Report Type: DA Access Report
Reference Number: 18163
Client: Rose Group
Site Address: 23 Fisher Road, Dee Why NSW

ACCESS REPORT

This Access Compliance Report is to accompany a Development Application for the development proposed at 23 Fisher Road, Dee Why, NSW

Typical floor plan for Unit AG.01, A.101, A201

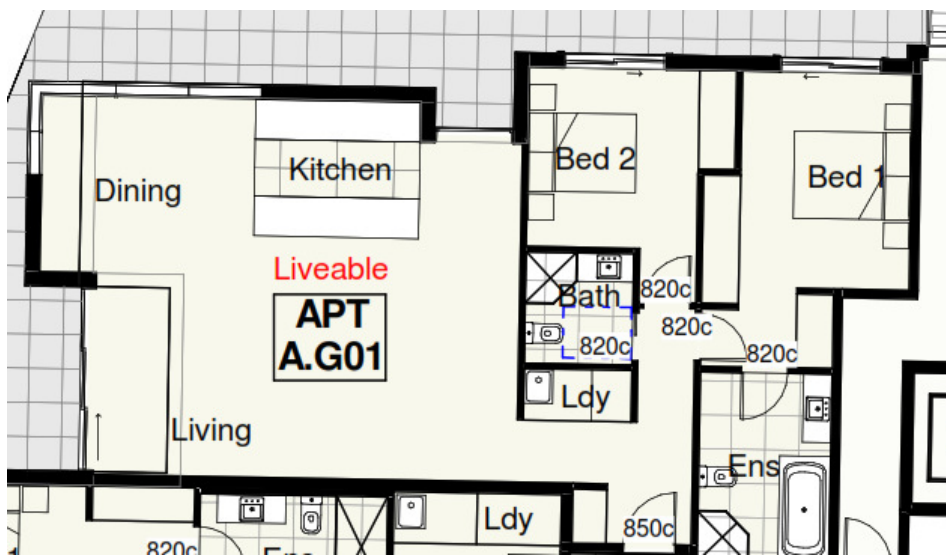
By incorporating the requirements of the below Checklist in the Specifications of the project, the nominated Livable units can achieve full compliance with Livable Housing Guidelines- Silver Level
